## ADDENDUM No. 1 TO THE CONTRACT DOCUMENTS

**Project:** City of Unalaska Light Cargo Dock Expansion

**Addendum Issue Date:** May 27, 2016

**Issued By:** Corey Roche  
PND Engineers, Inc.  
1506 West 36<sup>th</sup> Avenue  
Anchorage, Alaska 99503

TITLE: **EXISTING CONDITIONS, DEMOLITION PLAN, & SURVEY CONTROL**

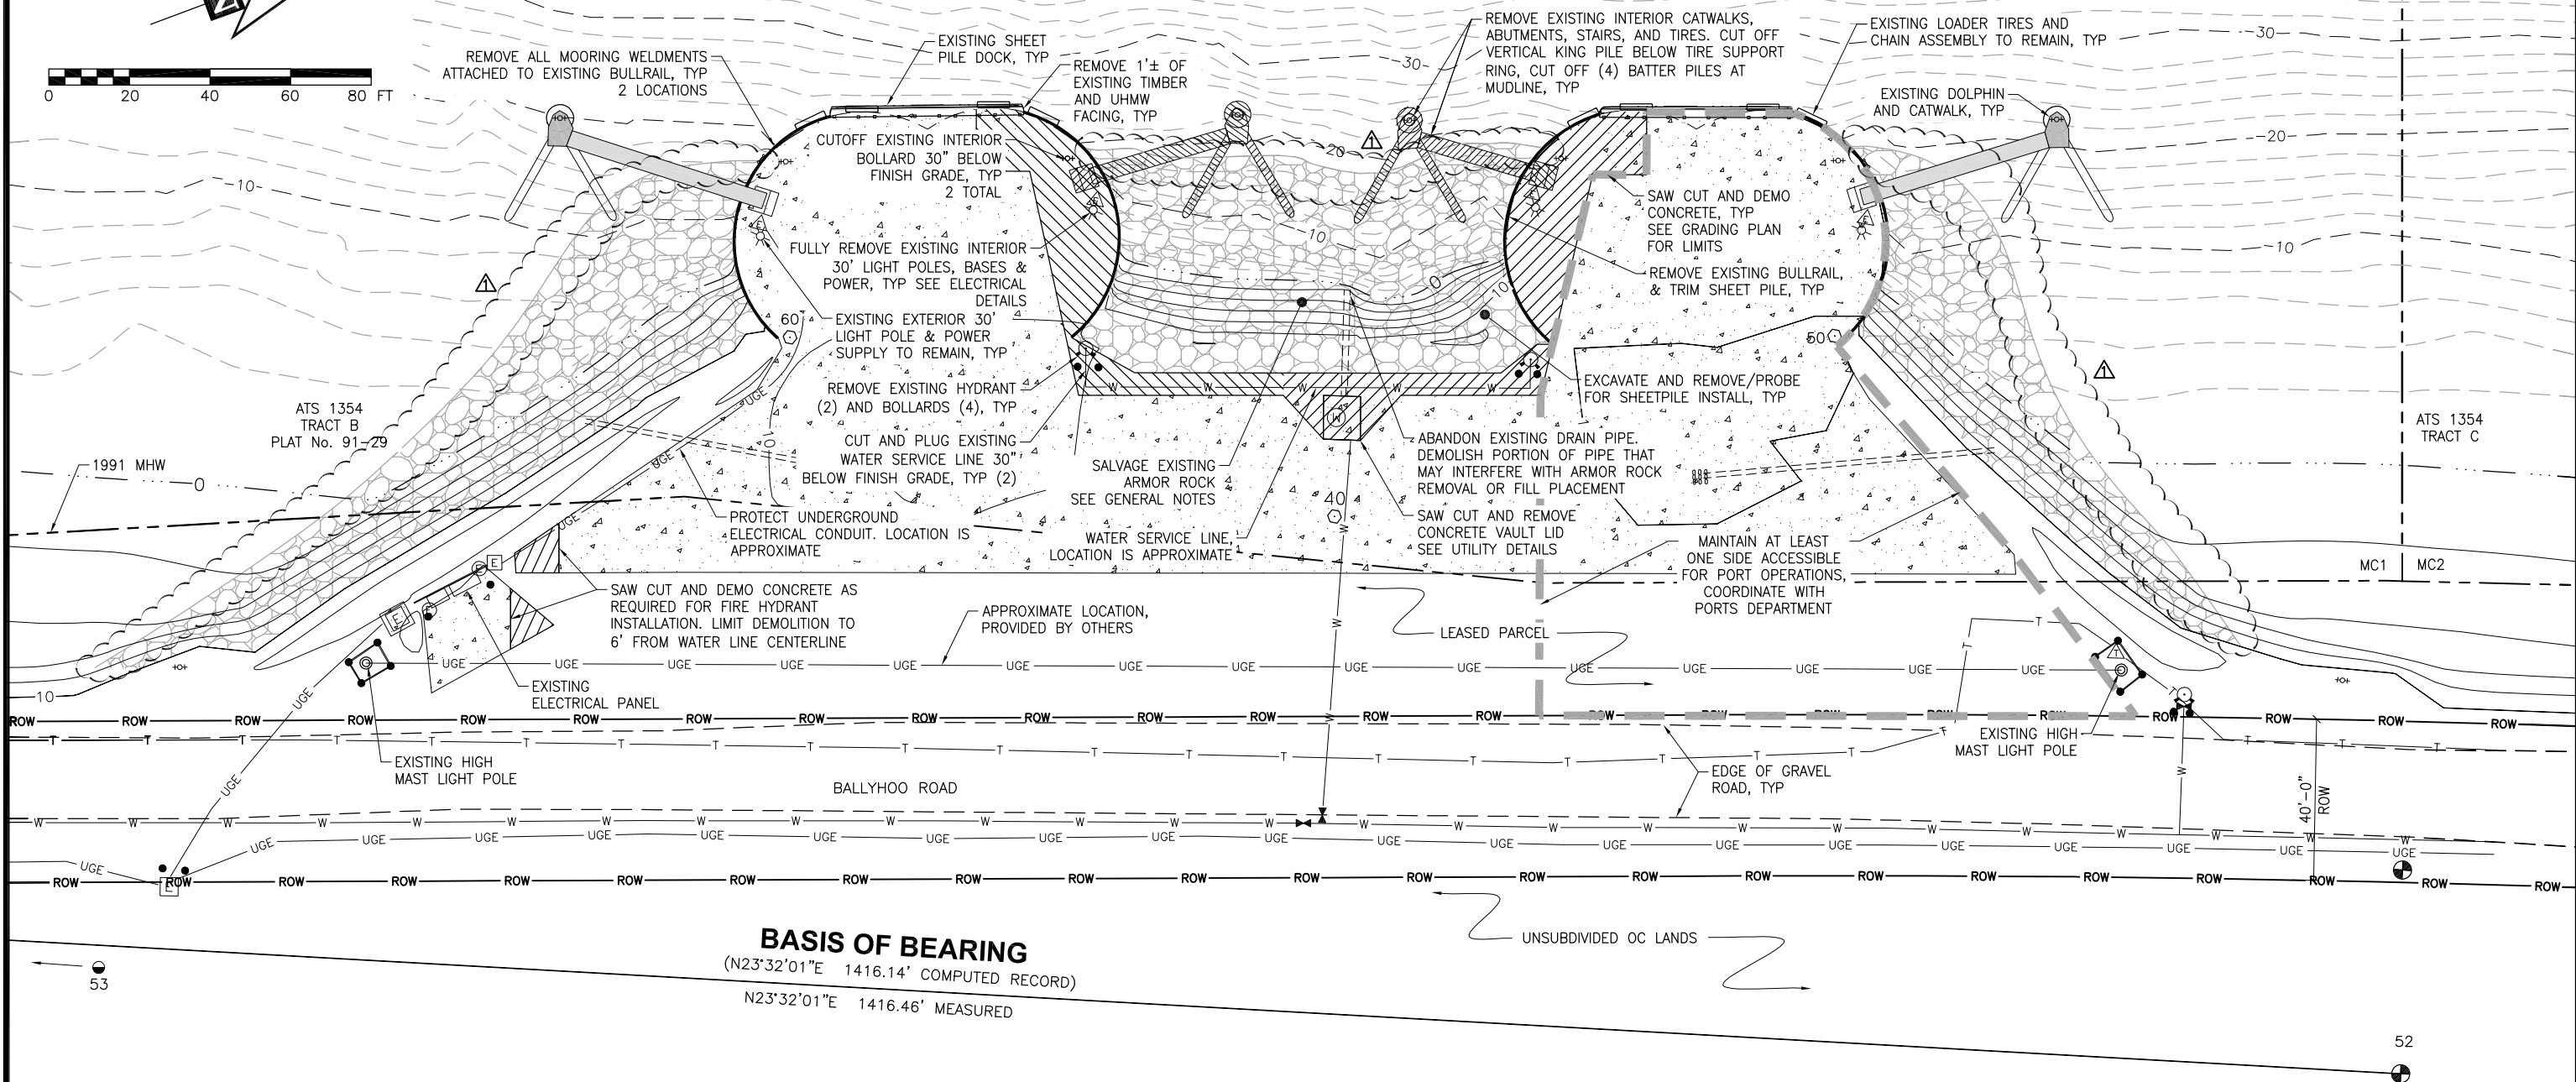
- Q7: Backfill Quantities... Bid item is lump sum... drawing show” Approximate Existing grade”.... How are we to calculate the amount of shot rock fill from data provide?.... There is insufficient details to accurately determine this quantity from what has been provided. PND has already calculated this in their budgeting(presumably) . Can this quantity take -off be provided or can CAD drawings and survey data of existing survey conditions be provided so we can calculate?

- A7: The referenced approximate grade on sheet 5 is for reference only and is an arbitrary section through the cell that varies depending on where the section is located. Sheet 2, Existing conditions, demolition, and survey control, shows the surveyed bathymetric data in the project location. This information in combination with the information and locations shown in the design drawings provide enough data to calculate fill volume.
